**Evaluation of Peach Bottom
Atomic Power Station Units 2 and 3
Offsite Dose Calculation Manual, Revision 5**

Docket No. 50-277, Facility License No. DPR-44
Docket No. 50-278, Facility License No. DPR-56

N. Morcos
D. W. Akers

Published July 1995

Figure 1. Liquid radwaste treatment system at PBAPS.

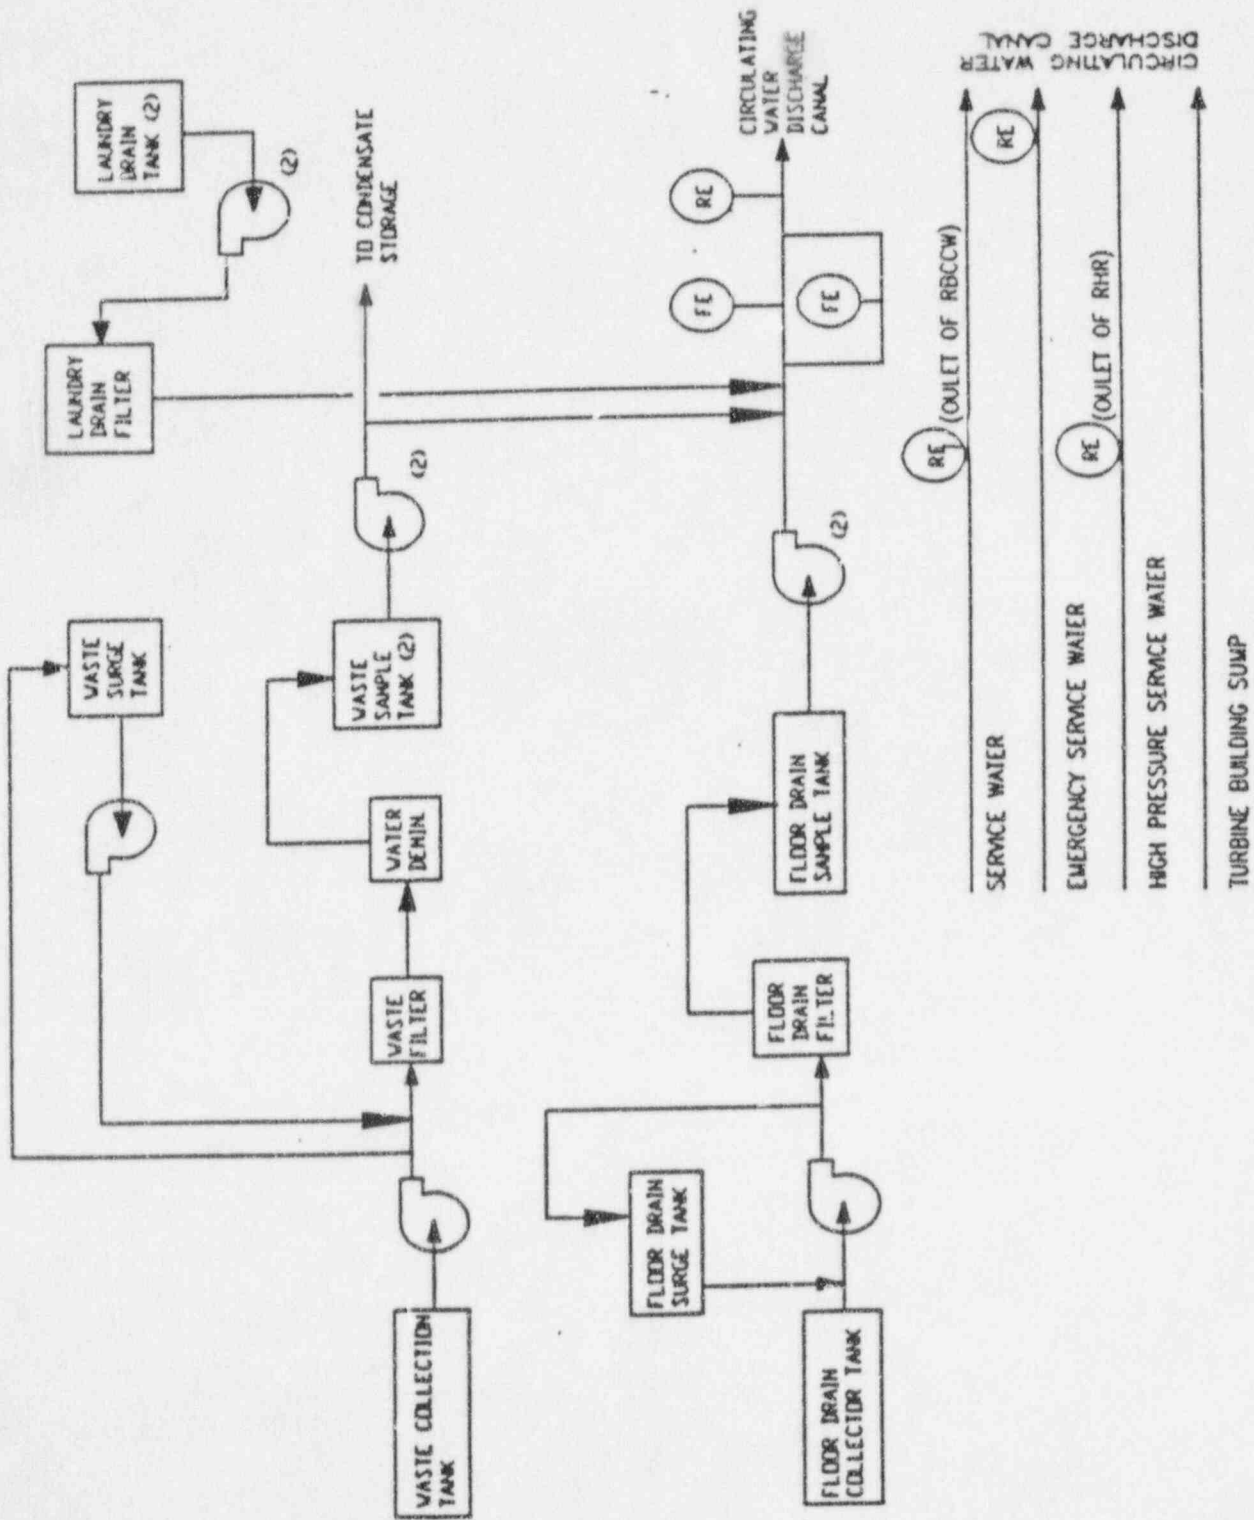
Figure 1 shows a schematic diagram of the PBAPS Units 2 and 3 liquid radwaste treatment system. The diagram clearly shows the source terms and liquid flow path, and associated monitors. However, it should also identify the monitor labels and indicate which of these monitors incorporates a termination of release capability in addition to the provision for alarms. In addition, it should be made clear whether all potential release pathways are monitored and are included in the ODCM calculations.

1. Figure 1 shows a schematic diagram of the PBAPS Units 2 and 3 liquid radwaste treatment system. The diagram clearly shows the source terms and liquid flow path, and associated monitors. It should also identify the monitor labels and indicate which of these monitors incorporate a flow shutoff capability in addition to the provision of alarms.
2. Radioactive gaseous effluents from PBAPS Units 2 and 3 are collected by the gaseous radwaste system and released to the atmosphere through the plant stack and reactor building vent stack. The gaseous effluent sources from both units are the main condenser air ejectors, startup pumps, and the gland seal condenser. However, the roof vent and associated monitor are not shown in the diagram.

Figure 2. Off-gas radwaste treatment system at PBAPS.

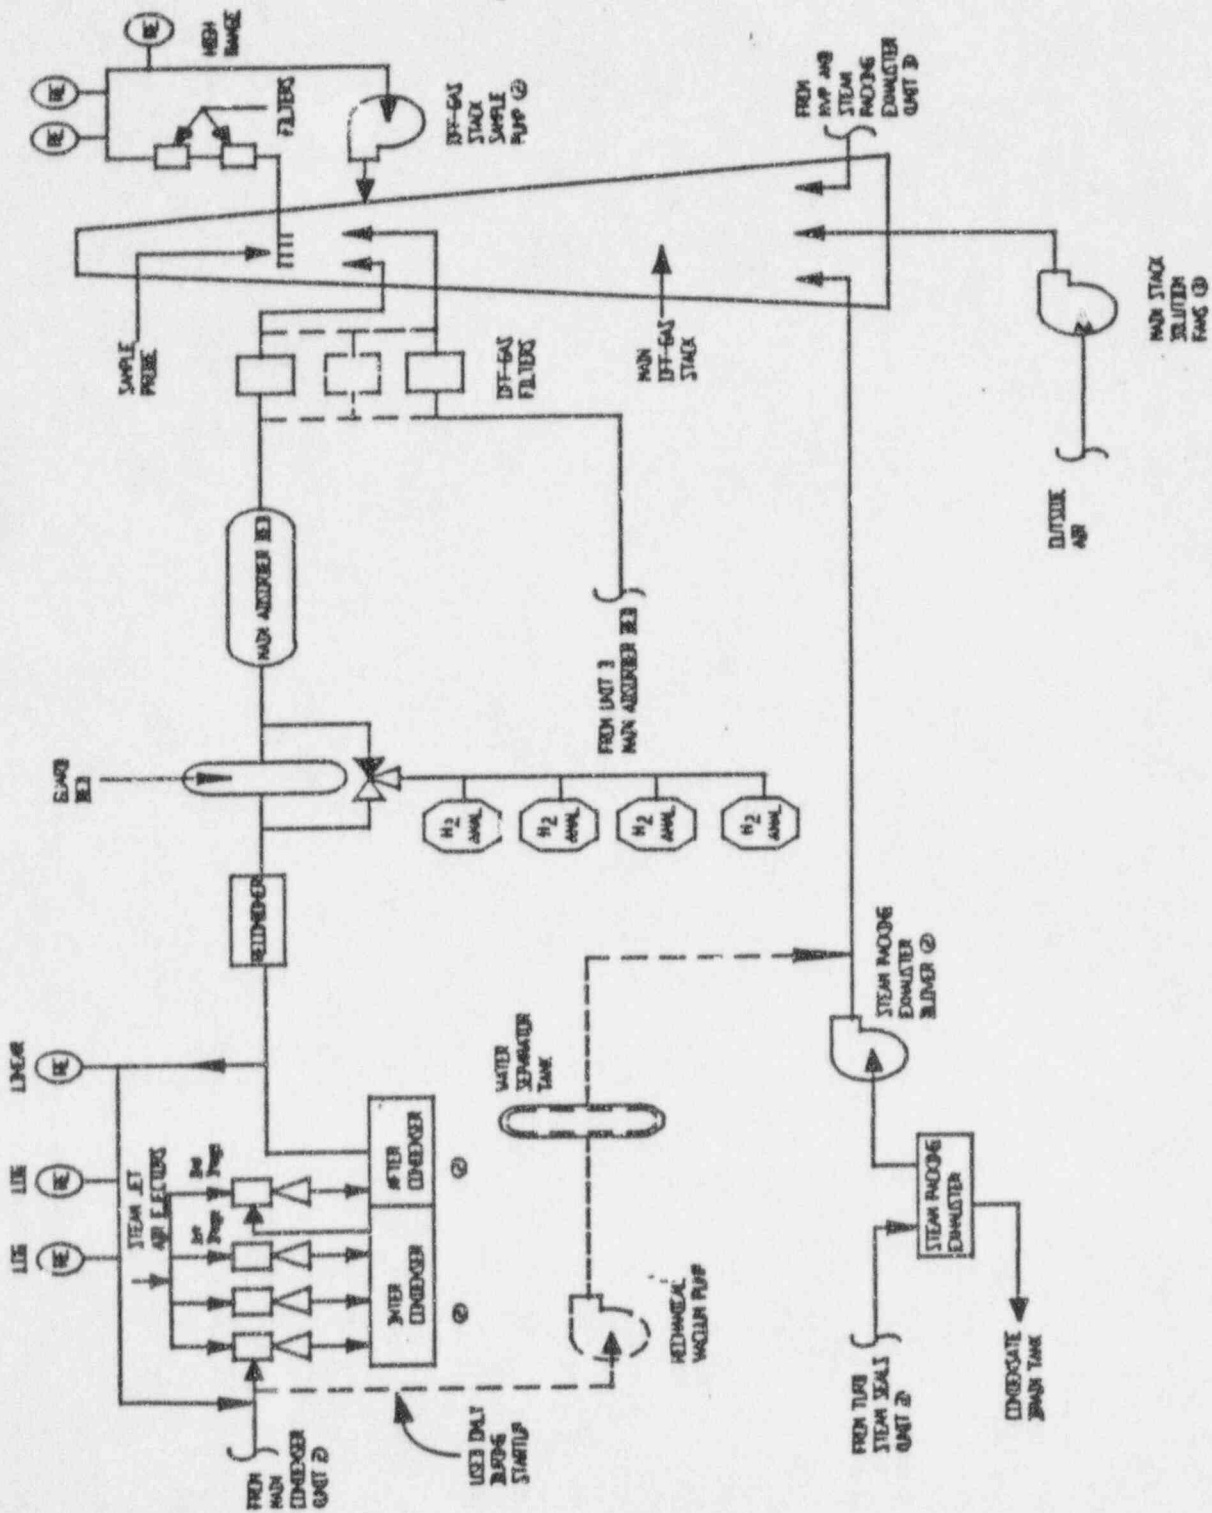
Radioactive gaseous effluents from PBAPS Units 2 and 3 are collected by the gaseous radwaste system and released to the atmosphere through the plant stack (Figure 2). In addition, there are radioactive gaseous releases from the ventilation exhaust waste treatment system, as shown in Figure 3. The gaseous effluent sources from both units are the main condenser air ejectors, the startup pumps, and the gland seal condenser. However, the roof vent and associated monitor are not shown in the diagram. The height of the plant vent stack should be specified in the ODCM to support the calculation of air doses.

1. The filtration system associated with the reactor building equipment cell (U2), recombiner building (U2), turbine building equipment cell (U2), radwaste equipment cell (U2), chemistry laboratory (U2), and fume hood (U2) should be described in the ODCM.
2. The ODCM should include a description of the gaseous radwaste system in addition to the schematic diagram.

Figure 3. Ventilation exhaust waste treatment system at PBAPS.

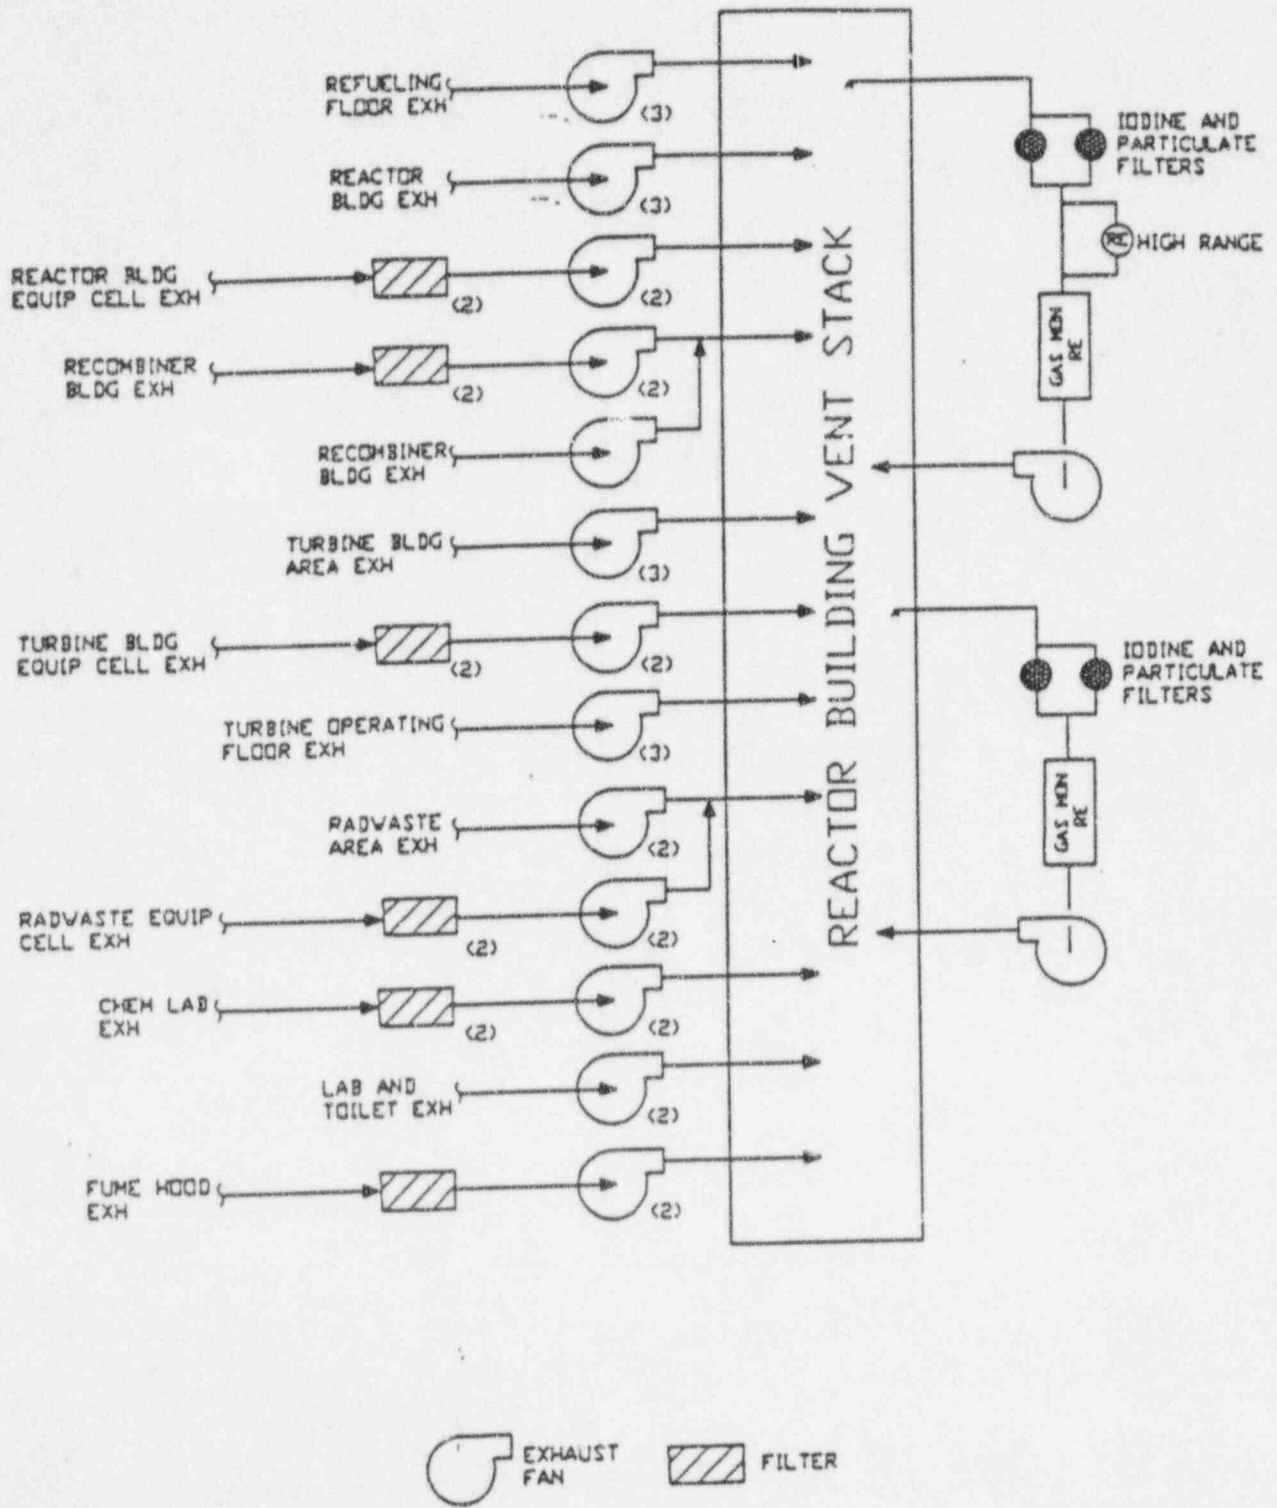
1. The roof vent and its associated monitor(s) should be shown in the ODCM.
